Timing in PHY startup (D2.1 Comment #169)

IEEE P802.3ch Multigig Automotive Ethernet PHY Task Force
Ad Hoc

Comment 169

Figure 149-33—PHY Control state diagram

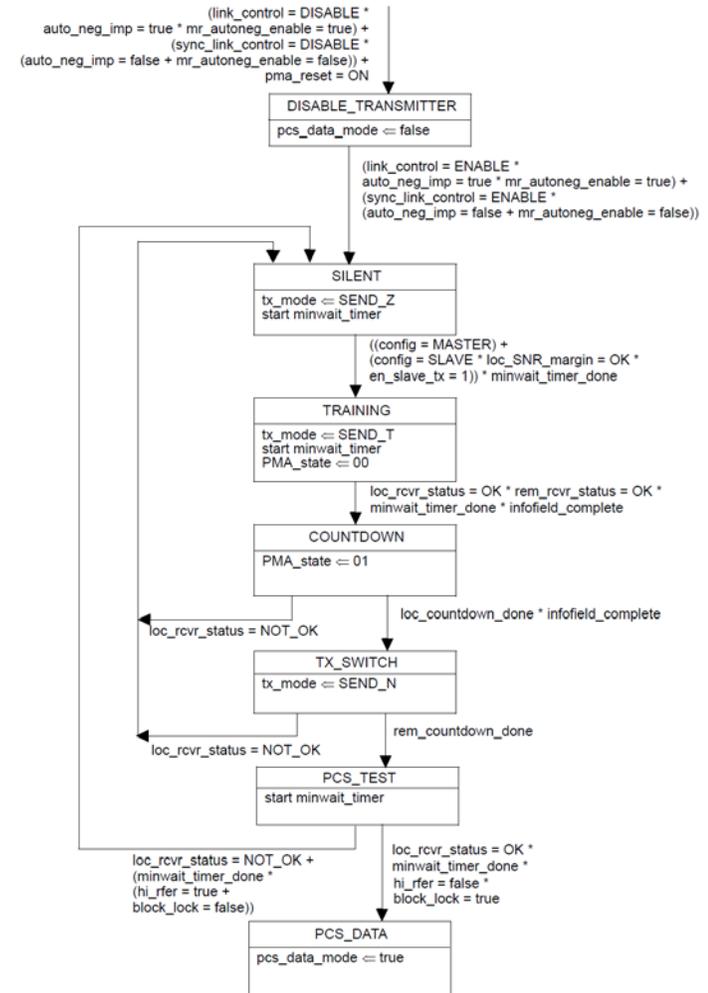
To ensure interoperability during the training phase, certain timing allocations between Master, Slave and other steps of training must be observed. We propose to the text of 802.3bz for interoperability and just scale the timing of 10G mode and deduct the timing for PCS_TEST that is set by min_wait_timer.

tModify Figure 149_33 as attached and Include the associated Table 145.15 in section 149.4.2.4.10 page 147, line 35 to read as follows

- PHY control must complete in no more than 97 msec or risk being terminated by the link_fail_inhibit_timer
 - 97 msec, Max = 98 msec (see 98.5.2)
- No timers control times in:
 - SILENT
 - TRAINING
 - COUNTDOWN/TX_SWITCH
- Experience from 10GBASE-T showed different designers made different assumptions of the time distribution
 - Discovered after initial publication, so it was a recommendation, not a requirement

Insert new final paragraph to 149.4.2.4.10 Startup sequence (Page 147 line 35): "The startup timing shall comply with Table 145-15."

Insert new table 145-15 at end of 149.4.2.4.10

Table 145-15: Maximum time spent in startup states (See Figure 149-33)

MASTER	Maximum time (msec)	SLAVE
SILENT plus (TRAINING state AND en_slave_tx = 0)	40	SILENT
TRAINING state AND en_slave_tx = 1)	54.439	TRAINING
COUNTDOWN plus TX_SWITCH	0.384 / S	COUNTDOWN plus TX_SWITCH
PCS TEST	1.025	PCS TEST
Total (for reference only)	95.464 + 0.384/S	Total (for reference only)
